[Docket No. FAA-2023-0921; Project
Identifier AD-2022-01430-T; Amendment
39-22471; AD 2023-12-13]

Airworthiness Directives; The Boeing Company Airplanes

ACTION: Final rule.

Figure 1 to paragraph (g)(2)(i)—*Fundamental Effective Isotropic PSD at Outside Interface of Aircraft Antenna*

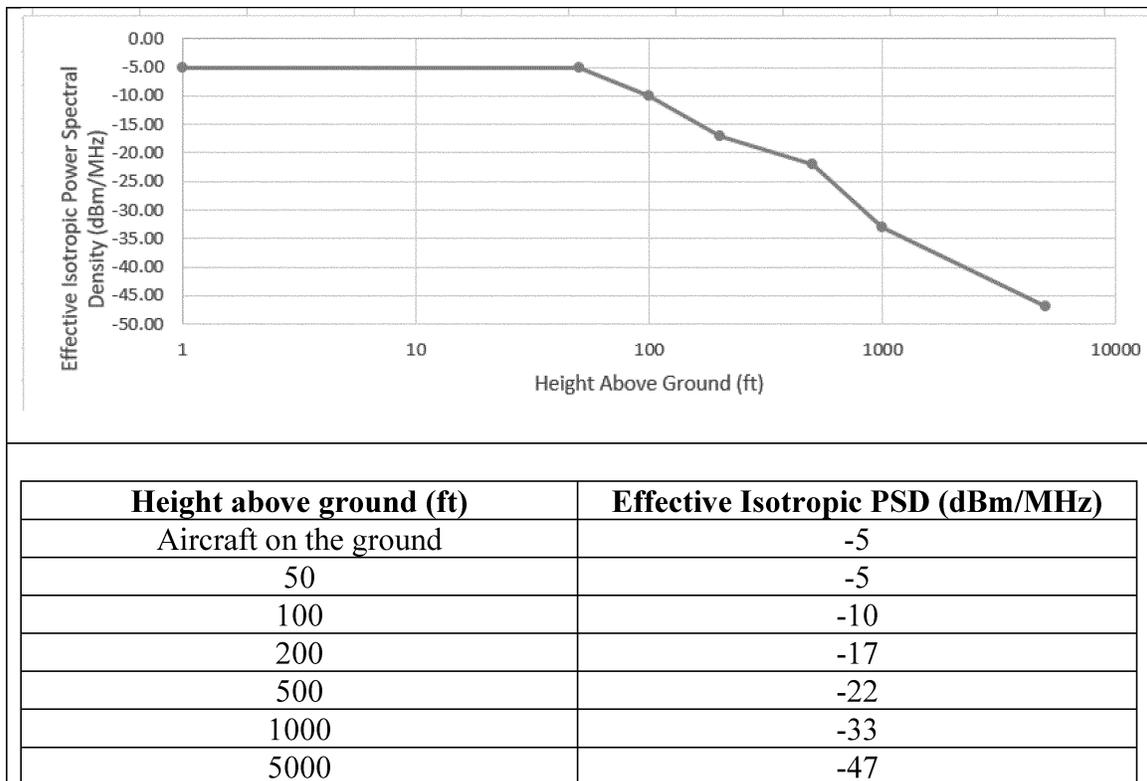
(i) Tolerance to radio altimeter interference, for the fundamental emissions (3.7–3.98 GHz), at or above the power spectral density (PSD) curve threshold specified in figure 1 to paragraph (g)(2)(i) of this AD.

Figure 2 to paragraph (g)(2)(ii)—*Spurious Effective Isotropic PSD at Outside Interface of Aircraft Antenna*

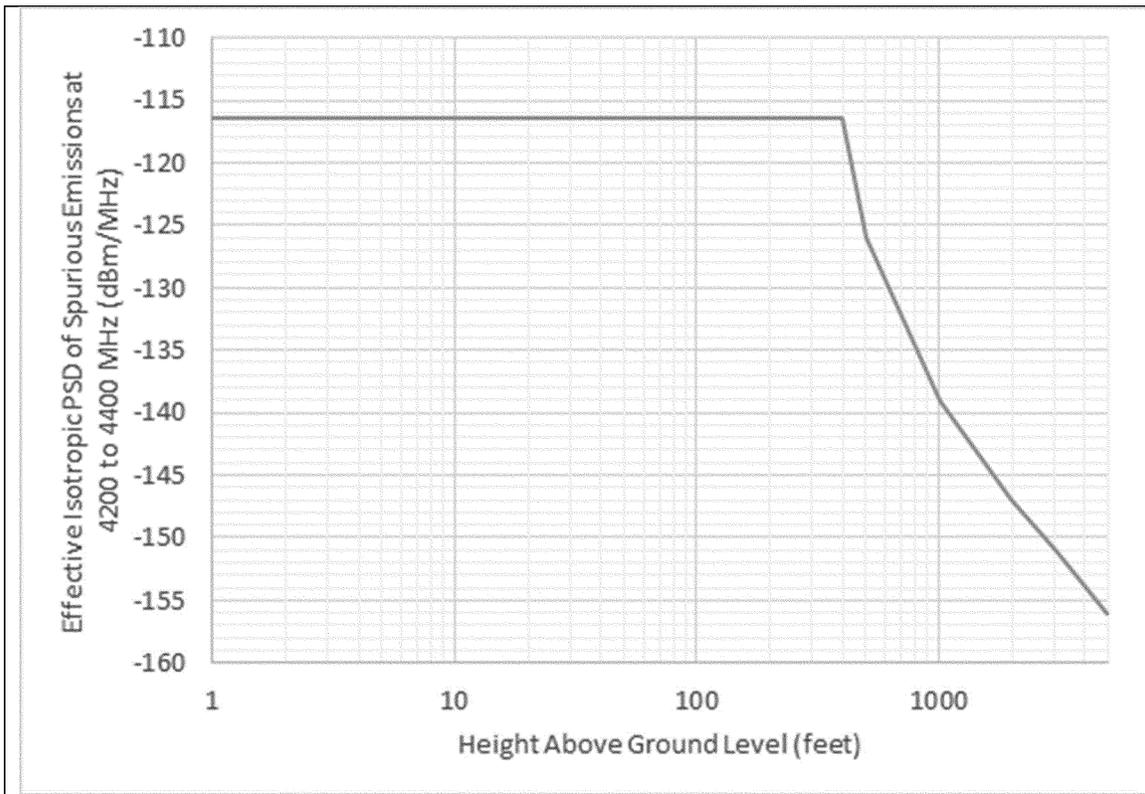
(ii) Tolerance to radio altimeter interference, for the spurious emissions (3.7–

3.98 GHz), at or above the PSD curve

threshold specified in figure 2 to paragraph (g)(2)(ii) of this AD.

<u>Aircraft Altitude (ft AGL)</u>	<u>Effective Isotropic PSD (dBm/MHz)</u>
1	-116.50
400	-116.50
500	-126.00
1000	-139.00
2000	-147.00
3000	-151.00
5000	-156.00
